Comparison of 2021 IECC Residential Cost Effectiveness Analyses

This document is intended to provide a comparison of two reports the *2021 IECC Residential Cost Effectiveness Analysis* published for the National Association of Homebuilders (NAHB) by Home Innovation Research Labs (HIRL) in June 2021, hereafter referred to as the HIRL report¹; and the report of the same name published by ICF in January 2022, hereafter referred to as the ICF report. The purpose of this document is to identify concerns and issues in the HIRL report, which were addressed in the ICF report.

Figure 1: Comparison of Builder Gross Profit Margin

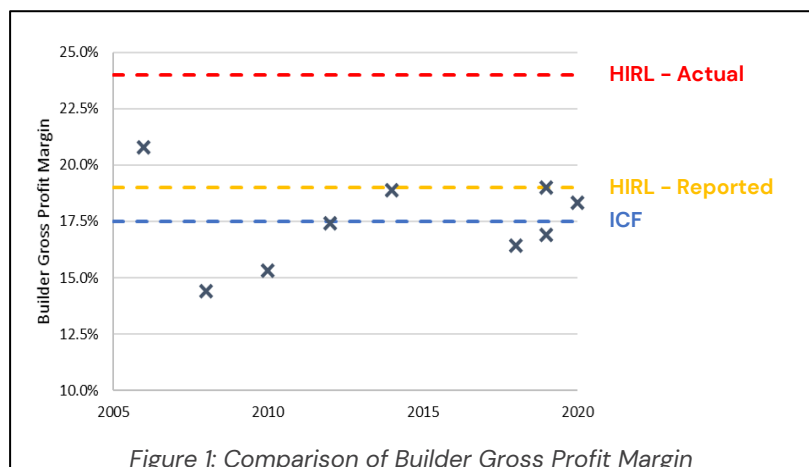
Additionally, the ICF report considered changes in builder profit margins over time and used an average value representing all data that was available. In figure 1, the data

available for builder gross profit margin is shown by black X's, with their average – the value used in the ICF report – shown by the blue line. The profit margin used in the ICF report is a more representative value, as the value reported to have been used in the HIRL report is the highest profit margin seen since 2006, and the value that was actually used is higher than any reported historical profit margin.

Figure 2: Comparison of 2021 IECC Code Change Costs

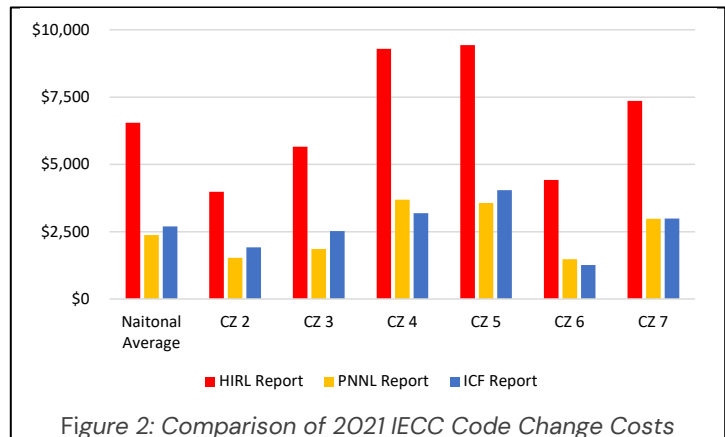
When reviewing the HIRL report, the high estimated incremental cost of code changes conflicted with other data sources, specifically Northwest national Laboratory’s (PNNL’s) *National Cost Effectiveness of the Residential Provisions of the 2021 IECC*, as shown in Figure 2.⁴ After reviewing and updating cost data, the ICF report concluded costs were generally in line with the PNNL report, instead of 2 to 3 times higher as shown in the HIRL report.

Figure 3: Comparison of Energy Cost Savings

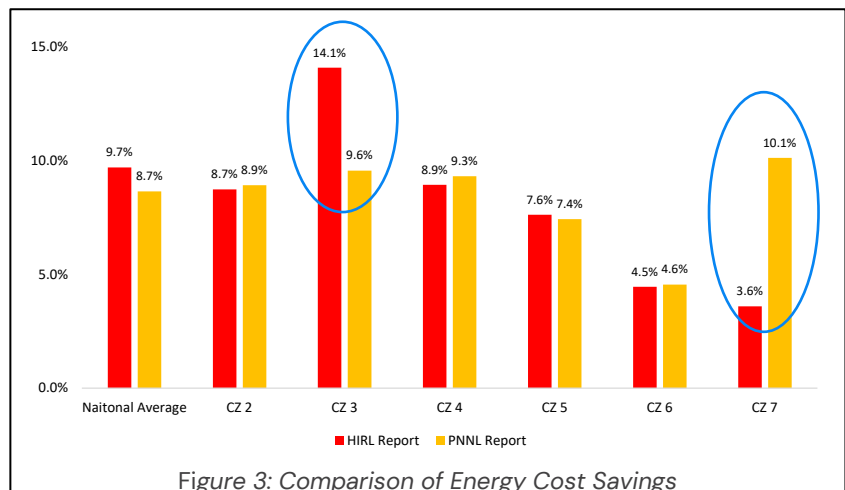
Savings from the HIRL report and PNNL’s savings estimates (*Energy Savings Analysis: 2021 IECC for Residential Buildings*⁵), were compared and national average savings were comparable (9.7% for HIRL and 8.7% for PNNL). However, some results in specific climate zones showed significant differences as shown in Figure 3 (i.e., climate zones 3 and 7). Due to the robustness of the methodology that PNNL’s savings estimates used, it is likely that there is an issue with the modeled energy use in the HIRL report. However, this cannot be confirmed, nor could the potential impact on the cost-effectiveness be determined.
